Teletype Corporation  
Chicago, Illinois, U.S.A.

Specification 5904S  
Issue 1, Page 1  
April, 1959

INSTRUCTIONS FOR INSTALLING THE 136132 OVERLOAD SWITCH ASSEMBLY ON A MU4 MOTOR UNIT OR 82283 SYNCHRONOUS MOTOR TO PROVIDE CURRENT OVERLOAD PROTECTION (USED ON MODEL 15 BASE (BB), MODEL 14 TYPING UNIT (FP), TYPING REPERFORATOR (FPR), NON-TYPING REPERFORATOR (RPE), TYPING REPERFORATOR TRANSMITTER (FRXD), AND TRANSMITTER DISTRIBUTOR (XD)

FIGURE I

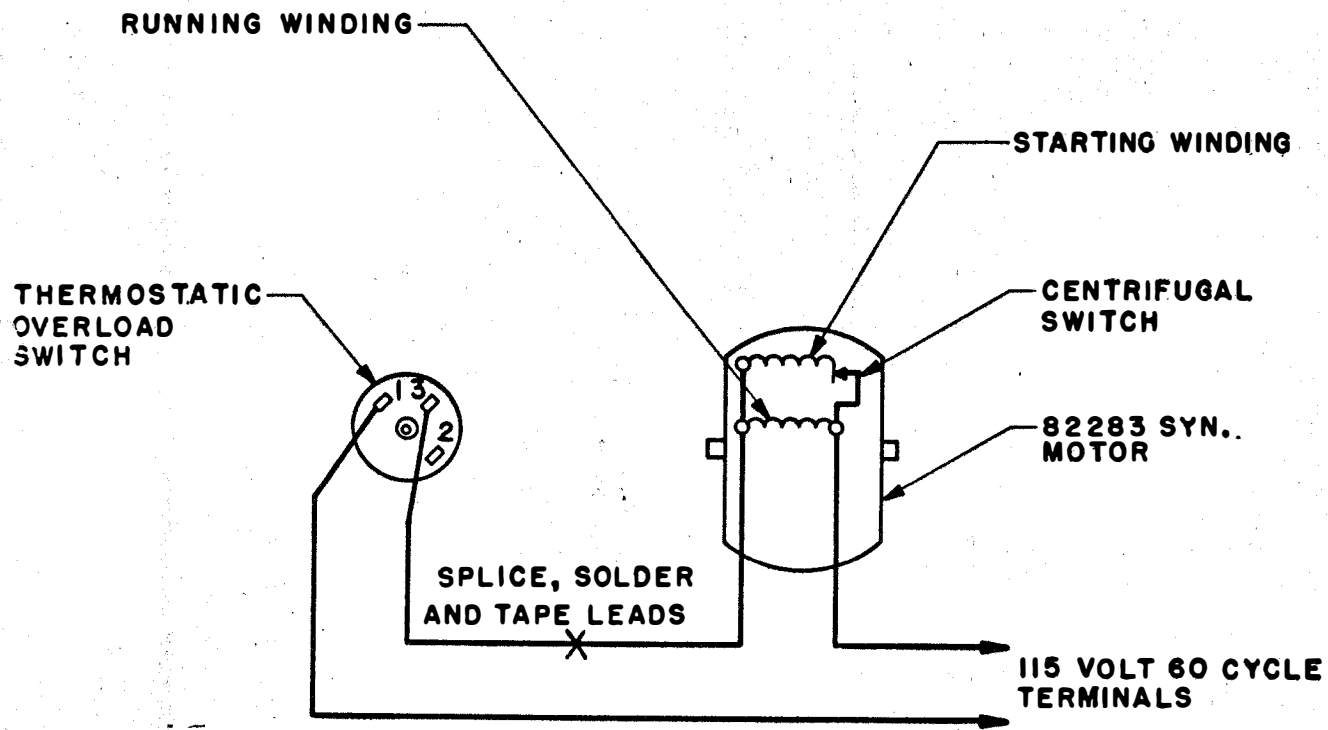
2. INSTALLATION (Figures 1 and 2)

b. Remove and retain one 78025 Screw and loosen the other 78025 Screw of the 82283 Motor Name Plate.

c. Mount the assembled 136132 Overload Switch Assembly on top of the motor over the name plate and under the loosened 78025 Screw. Replace the 78025 Screw and tighten, so that the 139630 Box is securely fastened to the 82283 Motor.

FIGURE 2

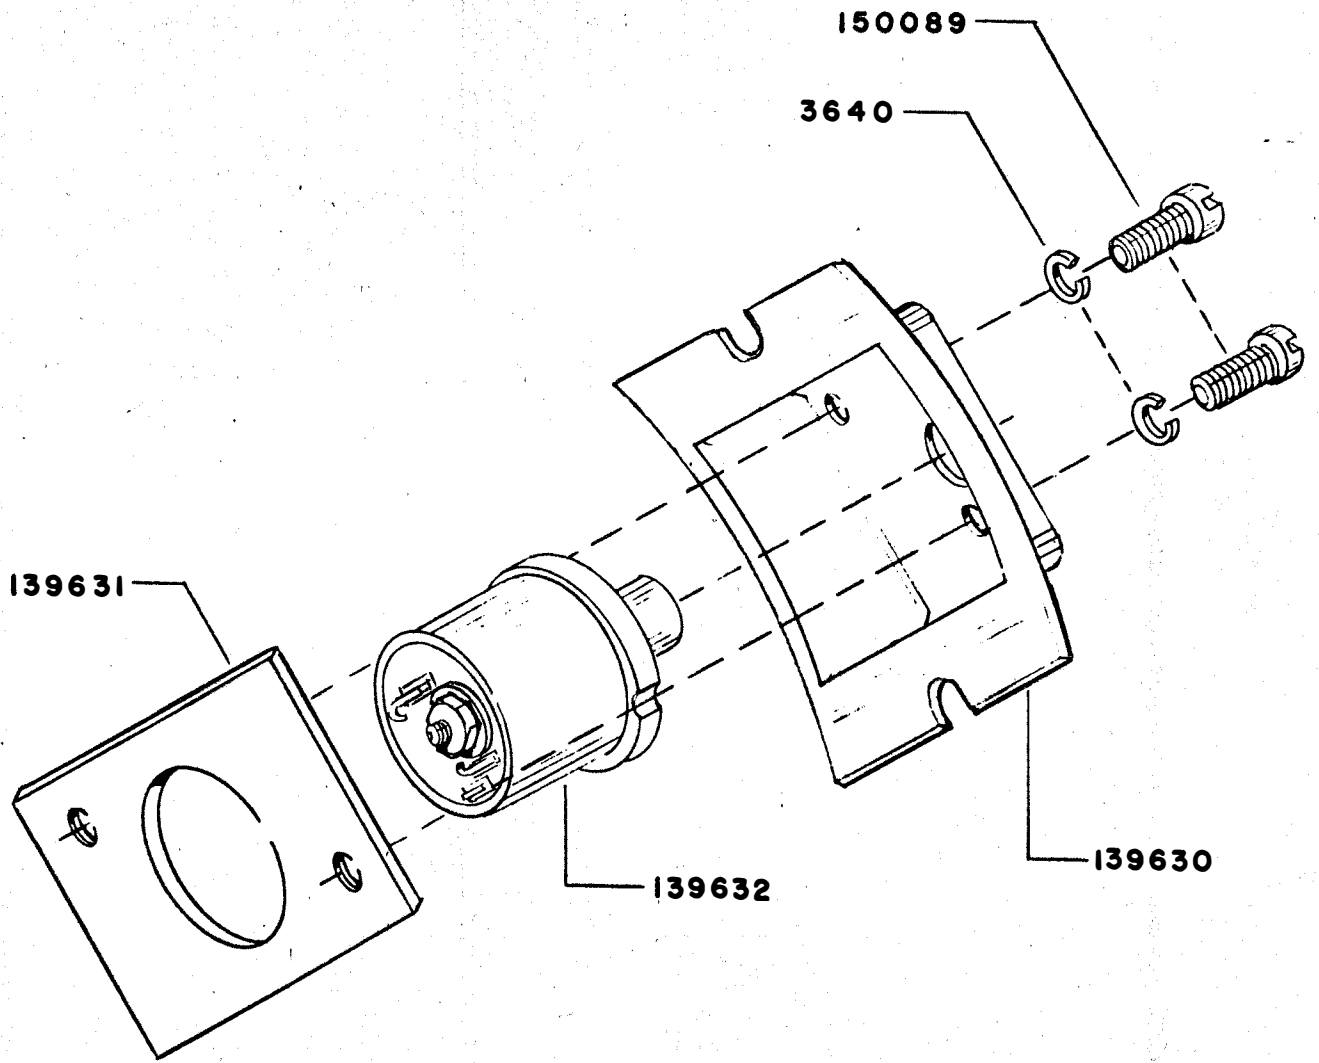
d. Both wire leads should follow the motor leads to the terminal block. Disconnect one motor lead from its 115 volt A.C. terminal source, splice, solder and tape to one of the thermostatic switch leads. The remaining switch lead replaces the motor lead removed from the 115 volt A.C. terminal source.
